REVIEWER #1 COMMENTS

This manuscript focuses on addressing the temperature-sensitivity issues inherent in dielectric-based soil moisture (SM) sensors, which often lead to spurious daytime peaks in diurnal cycles. The authors propose an empirical correction method based on Fast Fourier Transform (FFT) by leveraging the physically consistent diurnal patterns from land surface model (LSM) reanalysis datasets. The performance of the adjusted SM data was validated against reference sensors and further evaluated through land-atmosphere coupling analysis. Overall, the study provides a practical and innovative solution to a long-standing problem in the hydrological community. The topic fits well within the scope of the journal. However, considering there are some critical methodological issues and data inconsistencies that need to be clarified, I recommend a major revision.

Revised title: “Adjusting Diurnal Error in Dielectric-Based In-Situ Soil Moisture Measurements via Fourier Time-Filtering Using Land Surface Model Datasets”

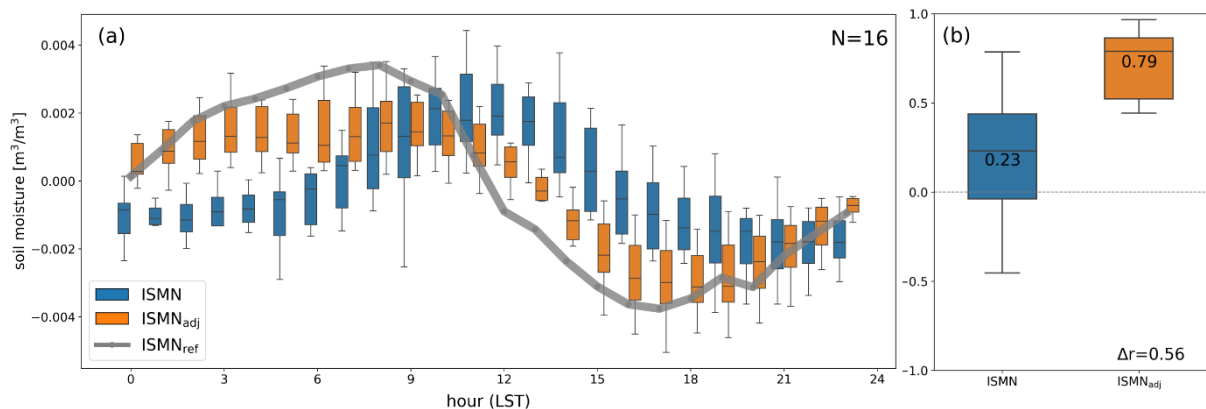
3. Regarding the precipitation filtering (Section 3.1), I have concerns about the consistency and physical basis of the thresholds used. The authors used a +1.5 standard deviation (SD) threshold for in-situ data but a 0.1 mm/day threshold for LSMs. (1) Since SM response to rain is highly dependent on soil texture and antecedent moisture, can a universal +1.5 SD threshold reliably identify rainy days across all global ISMN sites? (2) Why was the 'previous day' (L206) excluded along with the rainy day, rather than the following day, which is typically affected by post-rainfall drainage? (3) The use of different filtering methods for models and observations may lead to mismatched samples in the FFT adjustment. The authors should justify these choices.

→ *Regarding the precipitation masking based on a soil moisture tendency threshold, as noted by the reviewer, soil moisture responses to precipitation vary with observation sites; thus, employing a single global threshold necessitates certain simplifications. To evaluate the practical efficacy of this approach, we conducted a sensitivity analysis using all collocated ISMN SM-precipitation station pairs (n=240). This analysis compared SM-based masking criteria against collocated precipitation observations across different thresholds (1.5, 1.0, and 0.5 SD).*

The masking performance was evaluated based on two key metrics: (1) the number of overlapping days identified as rainfall-affected by both precipitation observations and the SM SD-based criterion, and (2) the proportion of observed rainfall days not detected by the SD-based threshold (the omission rate). The results (below contingency tables) indicate that the initial 1.5 SD threshold primarily captures only intense and abrupt SM spikes, thereby missing a substantial number of moderate precipitation events. In contrast, a lower threshold of 0.5 SD yields a more balanced identification, enhancing the agreement with observed rainfall days while significantly reducing the fraction of missed events. Based on these results, we revised the threshold from 1.5 SD to 0.5 SD in the updated manuscript (Lines 208-214 and Fig. S2).

"To exclude rainy days at observation sites, hourly SM measurements are aggregated into a daily resolution to calculate the day-to-day SM tendency. When this tendency exceeds a threshold of +0.5 standard deviations (SD), determined over the entire analysis period, both

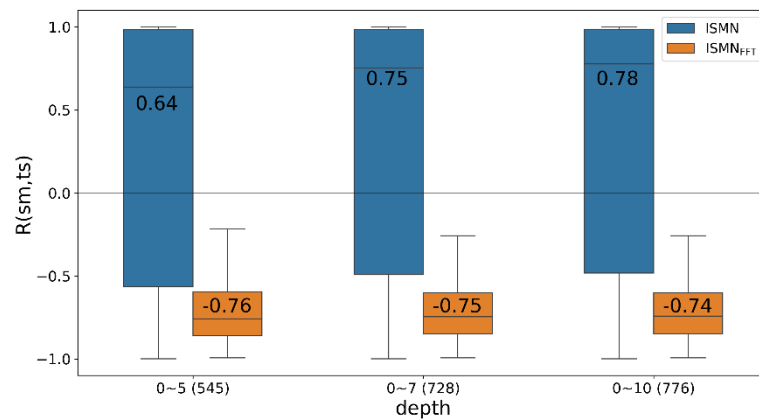
5. There is a clear discrepancy between the measurement depths of the LSMs (0–7 cm for ERA5-Land, 0–5 cm for MERRA-2) and the in-situ sensors (top 10 cm). Soil moisture and temperature in the top few centimeters are often Using the diurnal power of a 0–5 cm layer to correct a 10 cm layer might introduce vertical representativeness errors. This point needs more rigorous justification.

→ *We acknowledge the reviewer's concern regarding the vertical representativeness mismatch between the LSM soil moisture layers (0–7 cm for ERA5-Land and 0–5 cm for MERRA-2) and the in-situ measurements representing the top 10 cm. The use of the 0–10 cm in-situ layer was initially motivated by consistency with widely adopted near-surface soil moisture definitions in reanalysis and land surface models (e.g., a top layer on the order of 0–10 cm).*

To assess the potential impact of this depth mismatch, we conducted additional sensitivity tests by restricting the analysis to in-situ sensors whose measurement depths most closely match the corresponding model layers. The resulting diurnal power and correlation characteristics showed no apparent differences compared to those obtained using the full 0–10 cm in-situ dataset.

These results indicate that, despite small differences in nominal layer thickness among datasets, the diurnal signal targeted in this study is sufficiently robust within the near-surface soil layer.

Therefore, we consider the use of the 0–10 cm in-situ observations to be appropriate for the purposes of diurnal-cycle-based adjustment. Additional explanation has been added to the manuscript, and the corresponding figure has been included in the Supplementary Material (Lines 311–317).

“Although the nominal layer depths vary between ERA5-Land (0–7 cm), MERRA-2 (0–5 cm), and in-situ measurements (top 10 cm), all datasets characterize near-surface soil moisture, where diurnal variability is most pronounced. To evaluate the potential impact of this vertical discrepancy, additional sensitivity analyses were conducted by grouping stations according to their specific measurement depths (0–5, 0–7, and 0–10 cm). The resulting correlation characteristics remained highly consistent across all depth groups (Fig. S5), suggesting that the vertical representativeness mismatch has a negligible influence on the diurnal signals analyzed in this study.”

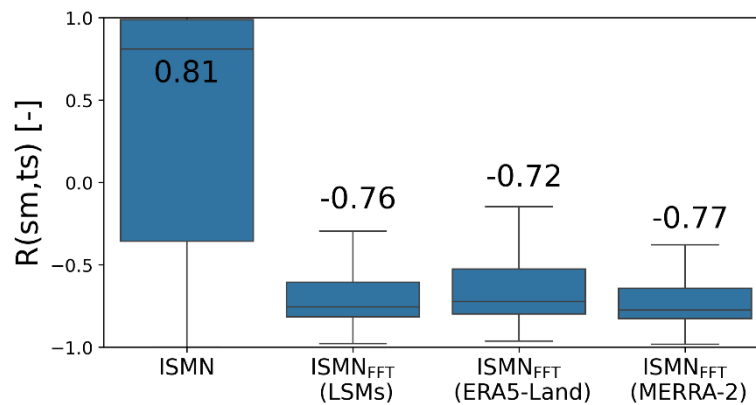
6. The correction relies on the assumption that sensors are insensitive to temperature during 20:00–06:00 LST. However, in many regions, soil temperature can remain high or continue to fluctuate significantly during the early night. Does this "baseline" assumption hold across all climate zones?

We appreciate the reviewer’s concern regarding potential soil temperature fluctuations during the early nighttime hours. To minimize the potential influence of such fluctuations, we revised the definition of the nighttime baseline period from 20:00–06:00 LST to a more conservative window of 22:00–04:00 LST. This narrower interval more closely represents the period when surface temperature variability is relatively stable and temperature-driven sensor artifacts are minimized. The manuscript has been revised accordingly in Lines 247–248 and 387–389.

“Assuming SM measurements to be relatively insensitive to temperature during the nighttime hours (22:00–04:00 LST) due to the absence of solar radiation, we further correct the mean of diurnal anomaly for each day.”

“Additionally, a diurnal mean correction (22:00–04:00 LST) is incorporated, assuming that the sensor temperature sensitivity is limited during nighttime periods when temperature-induced errors are minimal, thereby serving as a baseline for the correction.”

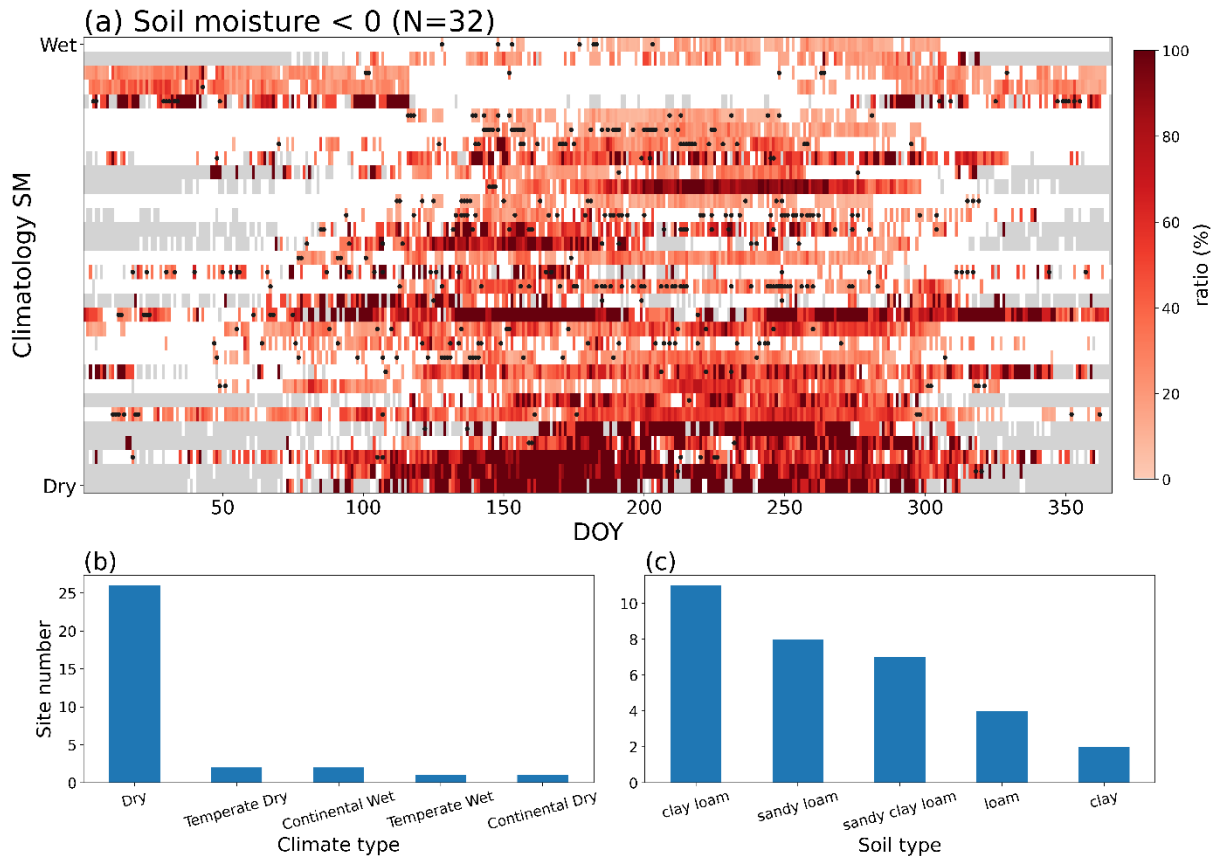
8. The application of standard normal deviate scaling (SNDS) to avoid negative values is an additional empirical step. I wonder if this scaling process significantly alters the original variance or the physical meaning of the diurnal amplitude.

→ We appreciate the reviewer’s comment regarding the use of SNDS. The occurrence of negative soil moisture values after phase adjustment was examined in detail. Among 745 stations, only 32 exhibited more than 100 hours of negative values, indicating such cases are relatively rare. These stations are predominantly located in dry regions with loam-type soil, where strong daytime heating can induce large diurnal amplitudes in soil moisture. During the phase-adjustment (1st) step, inversion of the diurnal cycle under these conditions can occasionally produce unrealistically low reconstructed values.

Importantly, soil moisture values below zero are physically implausible and therefore require correction. The SNDS procedure is applied only to these limited cases to prevent non-physical values while preserving the daily mean soil moisture. Because the adjustment affects only a small subset of stations and observations, and does not modify the daily mean, its impact on the overall variance and the physical interpretation of the diurnal amplitude is expected to be minimal. The corresponding details are explained in Lines 255-260 and Fig. S4.

“To evaluate the extent of this supplementary SNDS adjustment, we quantified the frequency of negative values across all stations. Only 32 stations exhibited more than 100 cumulative

hours of negative SM following the phase-adjustment step. These stations are primarily located in arid regions with loamy soils (Fig. S4), where strong daytime heating induces disproportionately large diurnal amplitudes. Since SNDS is restricted to these infrequent occurrences, its impact on the overall variance structure and the physical interpretation of the diurnal signal remains negligible.”

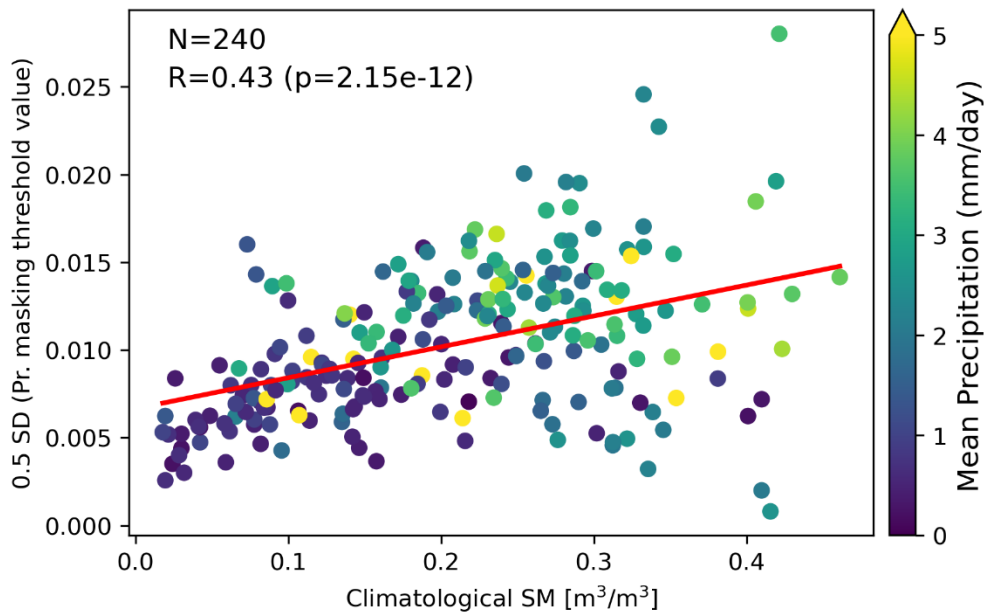
1) L205-207: The +1.5 standard deviation threshold for excluding rainy days seems somewhat arbitrary. Is this value robust for both humid and arid regions?

➔ *We evaluated the potential climate dependence of the +0.5 SD threshold by examining its relationship with climatological mean SM across stations with precipitation observation data. The regression pattern shows that climatological SM generally increases from approximately 0 to 0.3 and exhibits a slight decrease in the 0.3–0.5 range, with the overall SM variability bounded within approximately 0.5. In comparison, the absolute magnitude of the +0.5 SD threshold is very small (approximately 0–0.02), which is much smaller than the typical range of climatological SM variation. Therefore, the threshold is applied at a scale that is negligible relative to long-term SM climatology, supporting the conclusion that the criterion is not sensitive to arid–humid climate separation. This explanation has been added in Lines 213-214 and Fig. S3.*

“notably, these threshold values vary according to local climatology, with higher thresholds assigned to wetter regions (Fig. S3).”

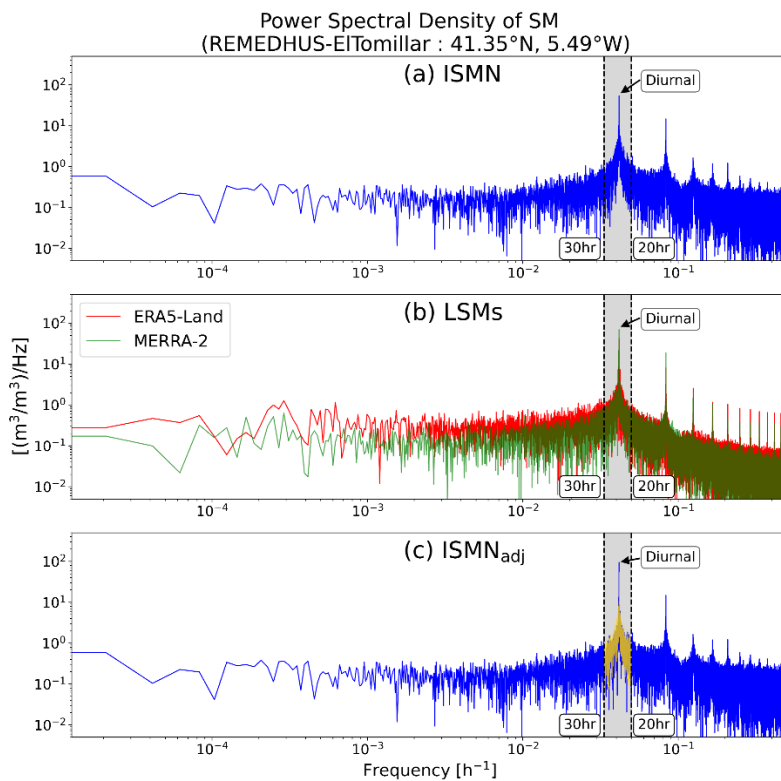
4. Methodology: The power spectral densities shown in the manuscript are unevenly distributed in frequency space, with sparse low-frequency bins and dense high frequency bins. This makes interpretation of the diurnal peak less robust. Recommend applying frequency or logarithmic smoothing to the power spectra.

➔ *Indeed, the diurnal frequency was not explicitly labeled in the original figure, which may have made its identification less clear to the reader. Although the peak corresponds exactly to $1/24 \text{ h}^{-1}$ and was confirmed to represent the maximum power within the diurnal band, this was not sufficiently highlighted in the visualization. To improve clarity, we have revised the figure to explicitly indicate the diurnal frequency in Figure 4.*

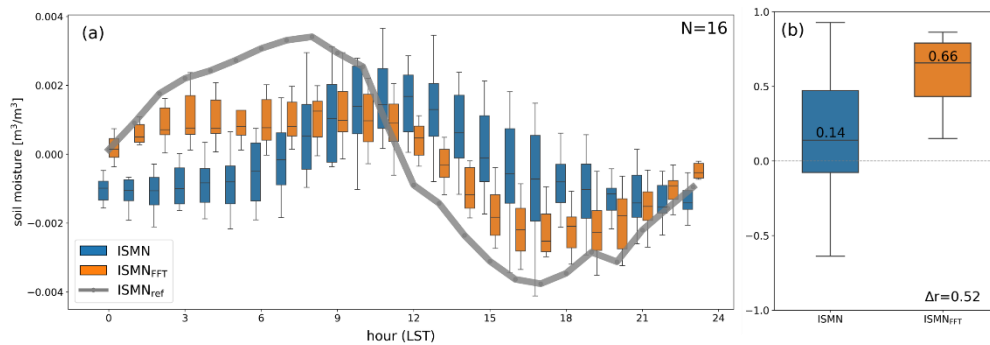
5. Results: The evaluation strategy compares adjusted SM time series with reference sensors located up

to 200 km away. Given the extreme spatial heterogeneity of soil moisture, such comparisons raise concerns about physical meaning. Even at distances of a few meters or hundred meters, SM can differ substantially due to soil texture, vegetation, topography, and land management.

→ *We agree with the reviewer that soil moisture exhibits strong spatial heterogeneity due to variations in soil texture, vegetation, topography, and land management, and that this can limit the physical interpretability of comparisons across large distances. The initial 200 km radius was chosen to ensure a sufficient number of reference sensor pairs for statistical evaluation, particularly in regions with sparse stations.*

Importantly, the evaluation targets the temporal correlation and phase consistency of the diurnal cycle, rather than absolute soil moisture magnitude. Even when mean soil moisture differs between sites, stations located within similar climatic regimes can exhibit comparable diurnal timing characteristics.

In response to the reviewer’s suggestion, we conducted a sensitivity analysis by reducing the distance threshold to 50 km. Although the number of available station pairs decreased from 20 to 16, the sample size remained sufficient for a statistically robust evaluation. Therefore, we adopted the 50 km distance criterion in the revised manuscript, which improves physical representativeness while maintaining adequate statistical reliability.
